**NEW YORK STATE THRUWAY AUTHORITY
DEPARTMENT OF ENGINEERING**

**ALBANY, NY
FEBRUARY 8, 2024**

**AMENDMENT NO. 1
TO**

**CONTRACT TANY 24-8
D214964
2" MILL AND INLAY, SAFETY
IMPROVEMENTS AND MISCELLANEOUS WORK
BETWEEN MILEPOST 47.6+/- AND MILEPOST 60.1+/-
IN THE NEW YORK DIVISION
OF THE NEW YORK STATE THRUWAY
IN ORANGE COUNTY**

CONTRACT NUMBER:
TANY 24-8
 DATE:
1/2024
 DRAWING NUMBER:
MD-5

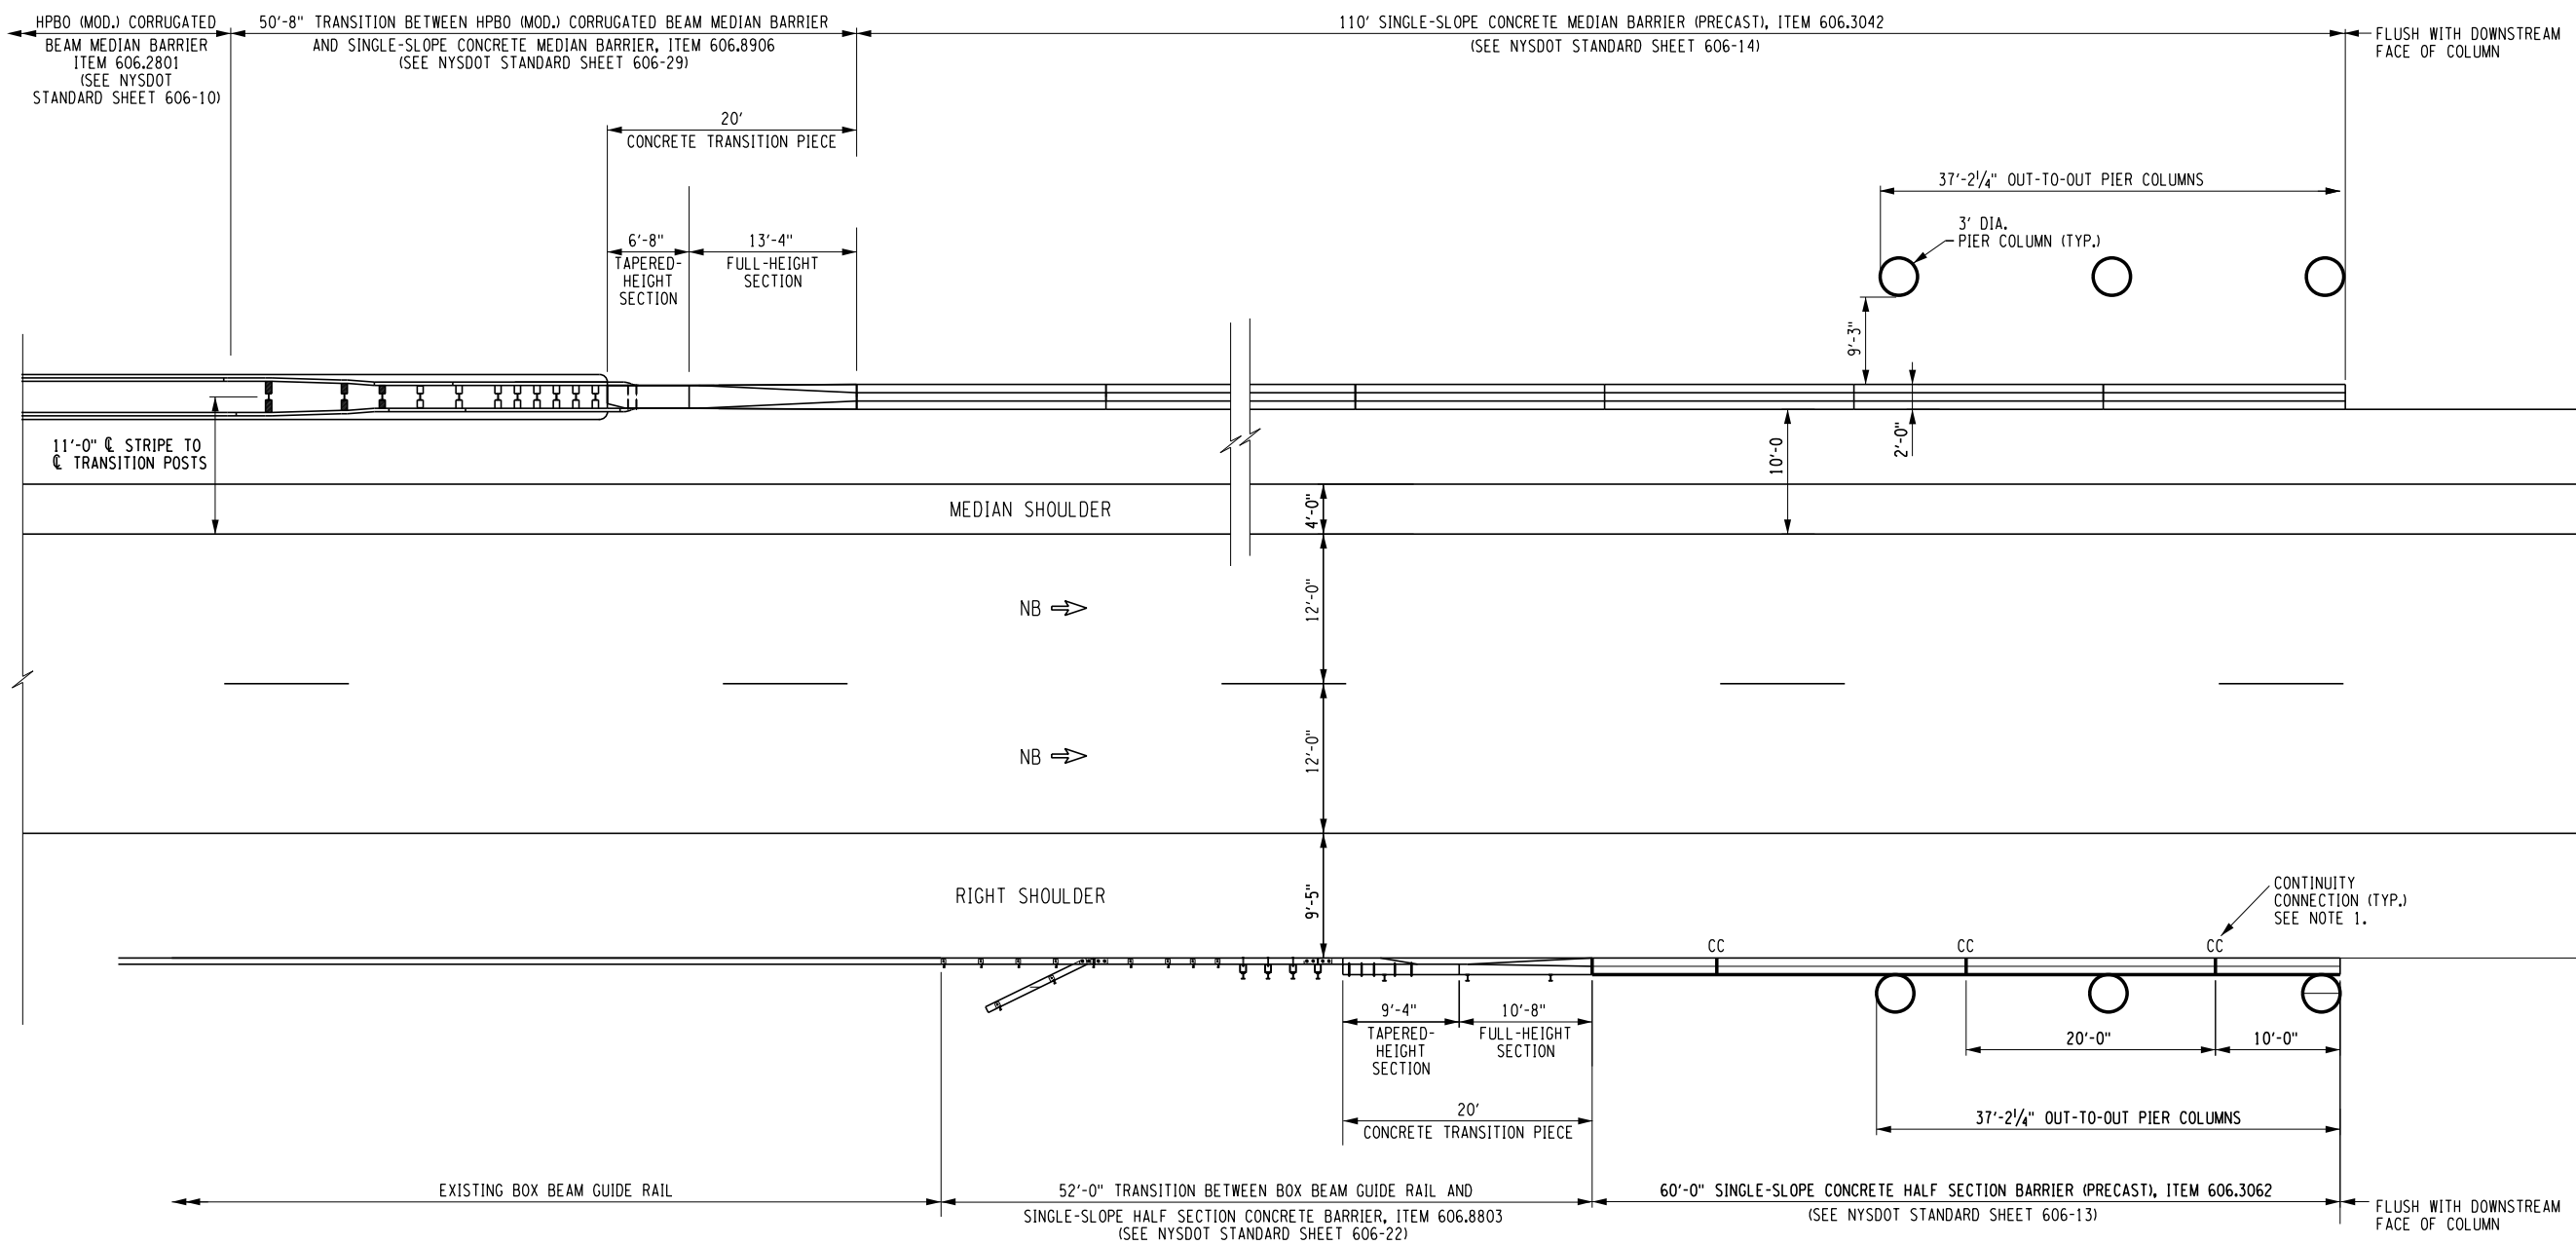
11. **DELETE** Drawing Number MD-5, Sheet 64 of 108, and **SUBSTITUTE** with the attached Drawing Number MD-5, Sheet 64-A1 of 108. The proposed locations of concrete barrier joints have been updated. Changed right side barrier length. Added Note 3.

TITLE OF PROJECT PAVEMENT RESURFACING AND SAFETY IMPROVEMENT	CONTRACT NUMBER: TANY 24-8
LOCATION OF PROJECT NY DIVISION MP 48.0 TO 60.1	DATE: 1/2024
TITLE OF DRAWING MISCELLANEOUS DETAILS	DRAWING NUMBER: MD-6

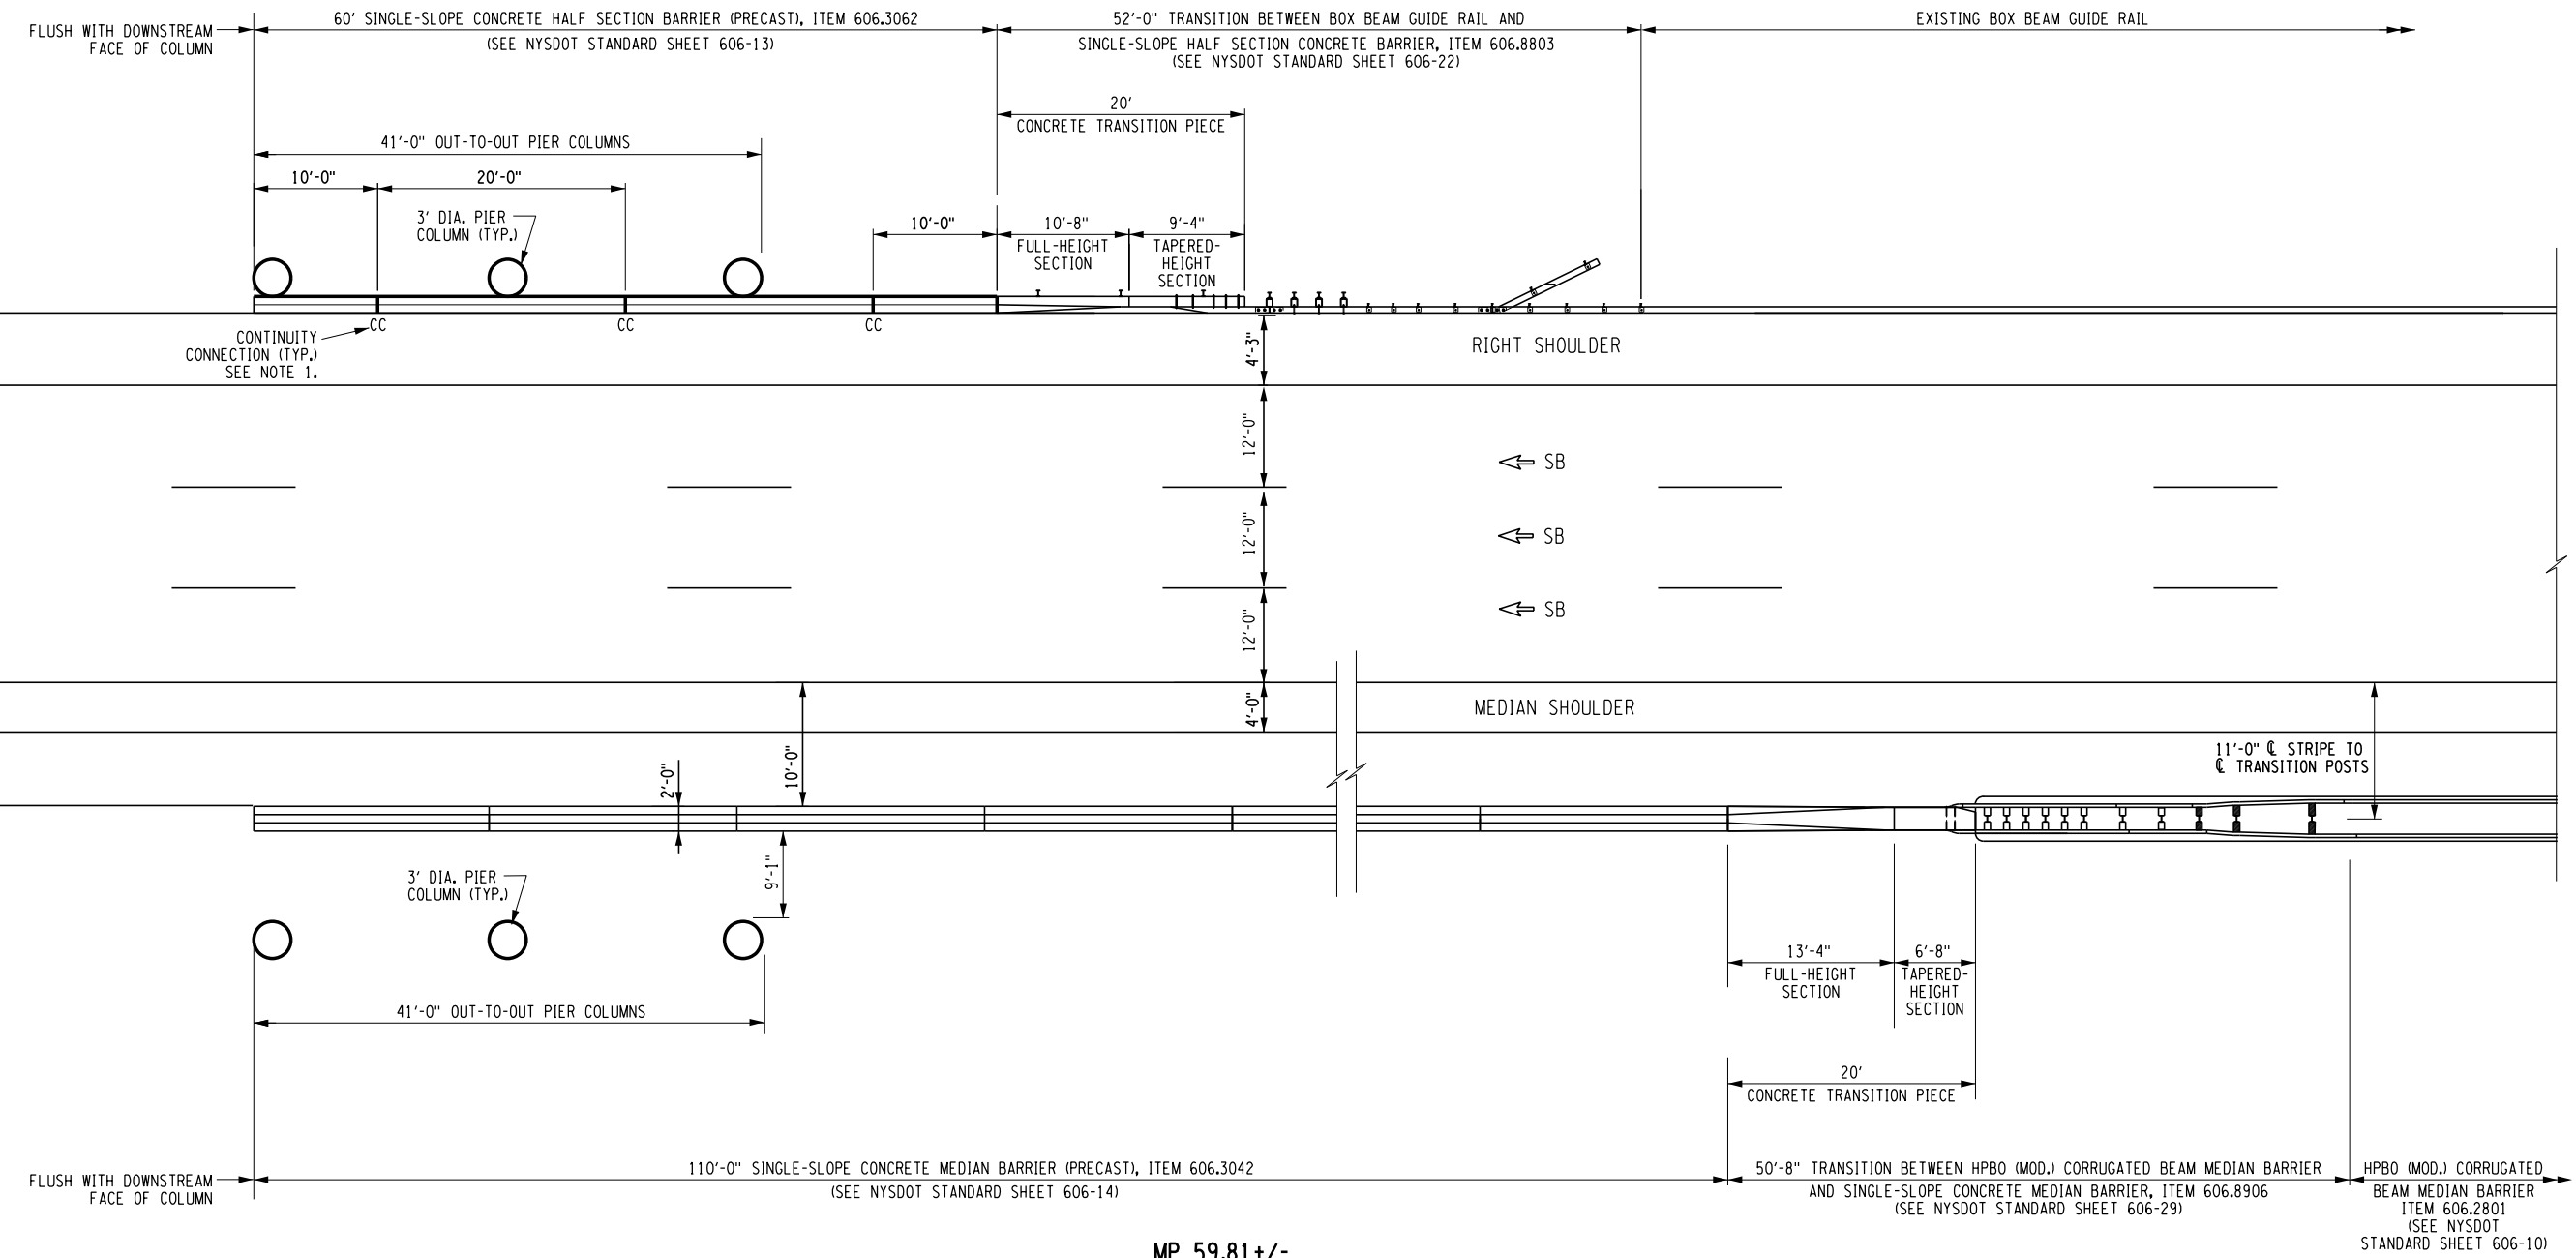
12. **DELETE** Drawing Number MD-6, Sheet 65 of 108, and **SUBSTITUTE** with the attached Drawing Number MD-6, Sheet 65-A1 of 108. The proposed locations of concrete barrier joints have been updated. Changed right side barrier length. Added Note 3.

TITLE OF PROJECT PAVEMENT RESURFACING AND SAFETY IMPROVEMENT	CONTRACT NUMBER: TANY 24-8
LOCATION OF PROJECT NY DIVISION MP 48.0 TO 60.1	DATE: 1/2024
TITLE OF DRAWING MISCELLANEOUS DETAILS	DRAWING NUMBER: MD-7

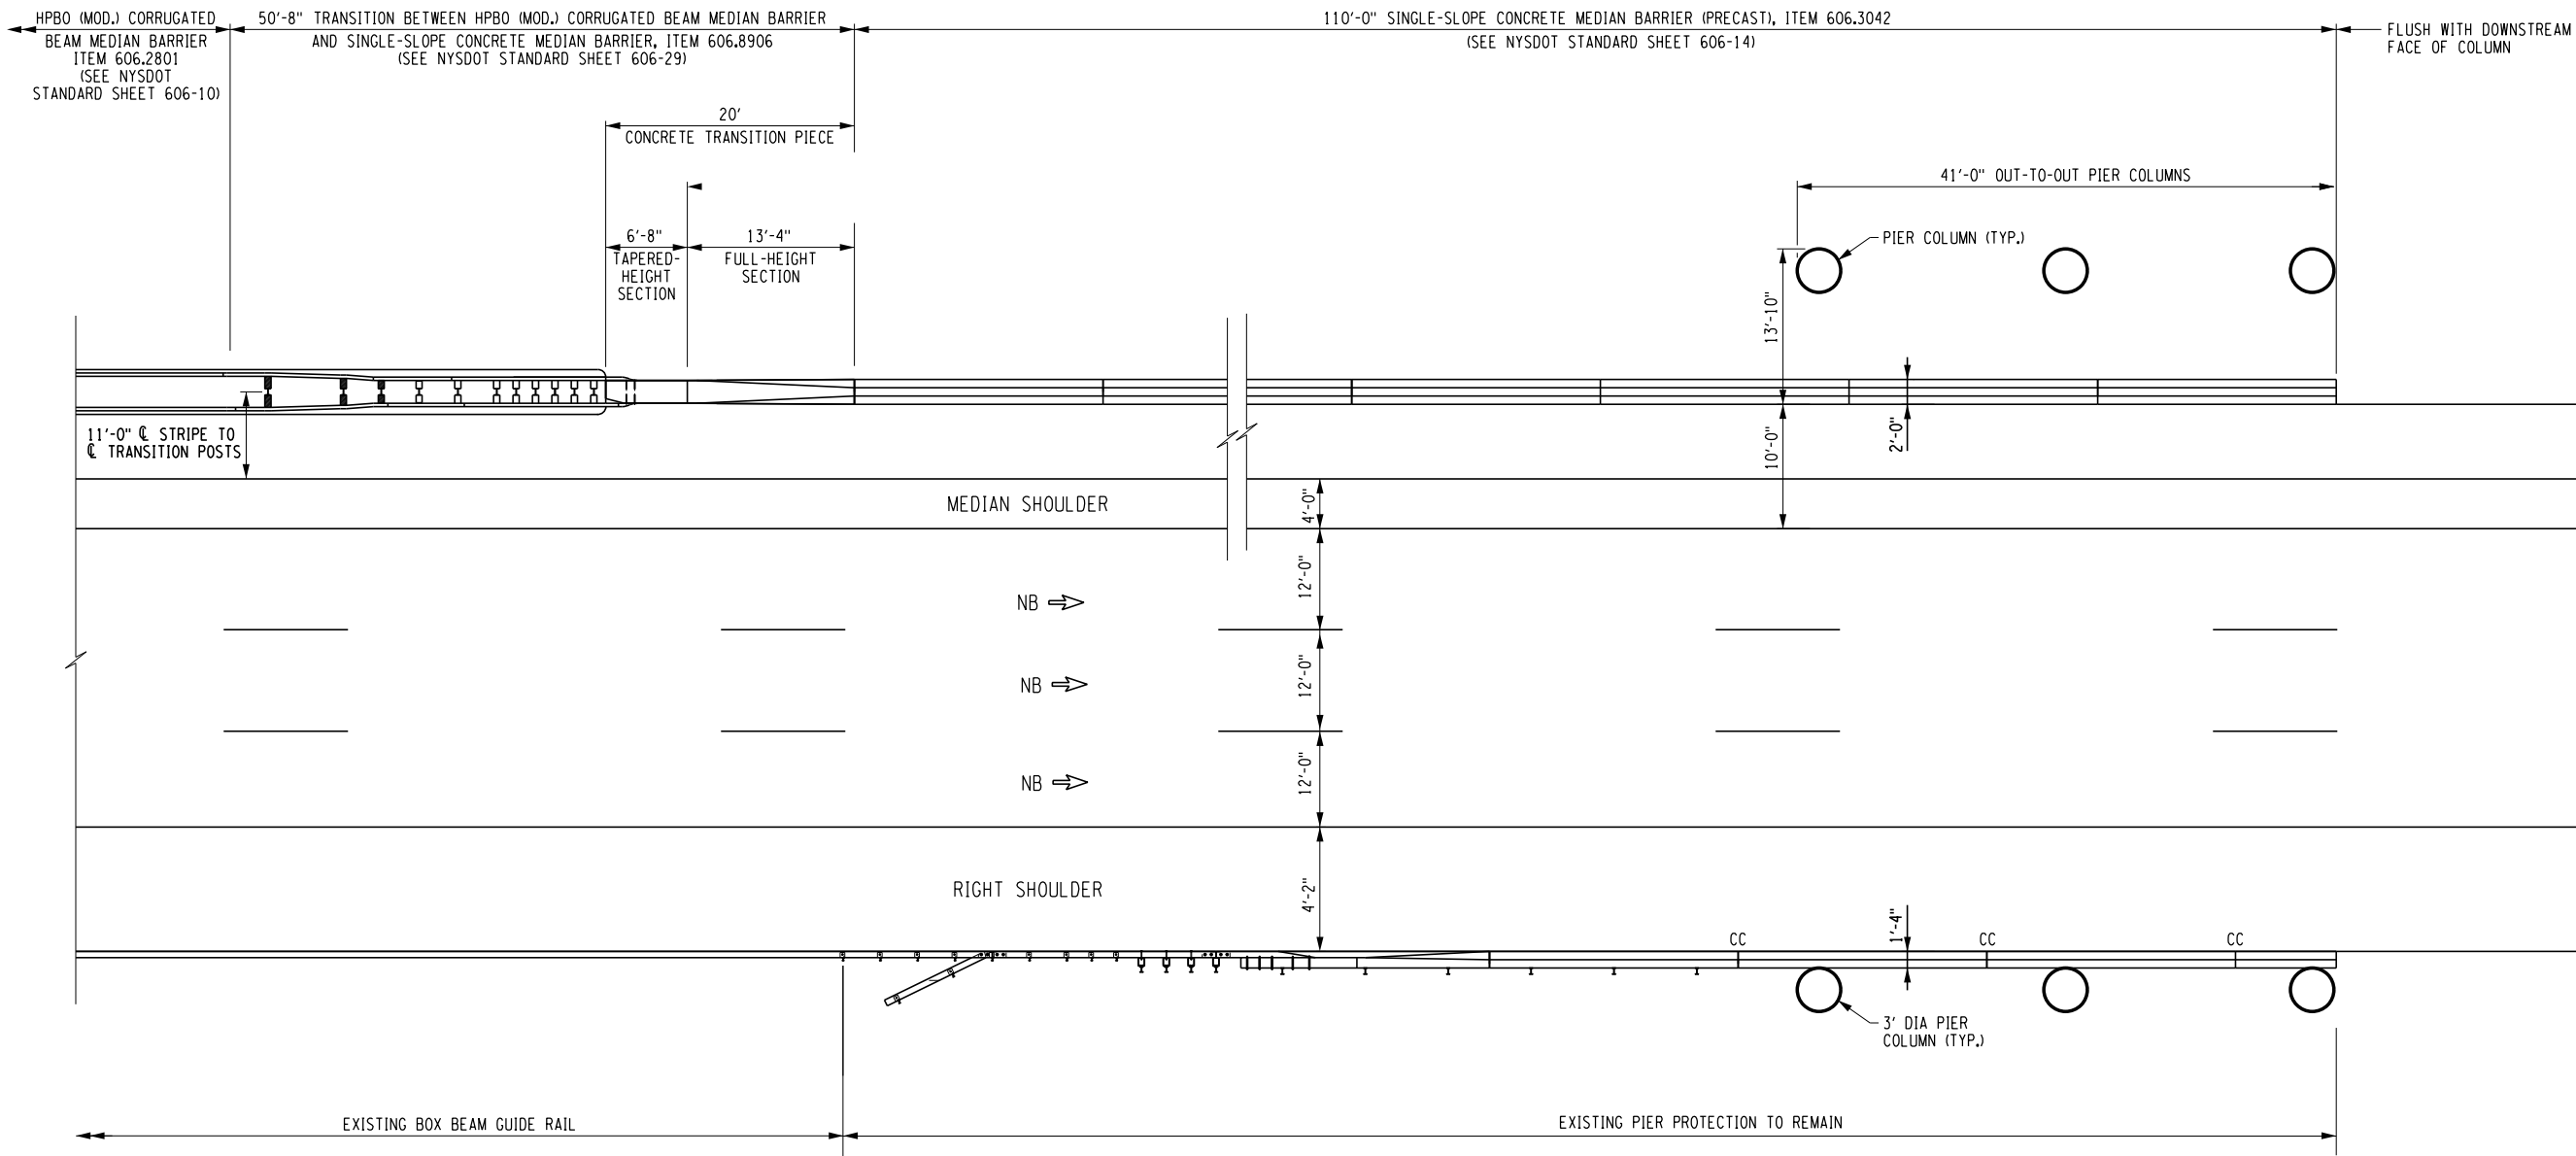
13. **DELETE** Drawing Number MD-7, Sheet 66 of 108, and **SUBSTITUTE** with the attached Drawing Number MD-7, Sheet 66-A1 of 108. Added median shoulder line. Added Note 3.
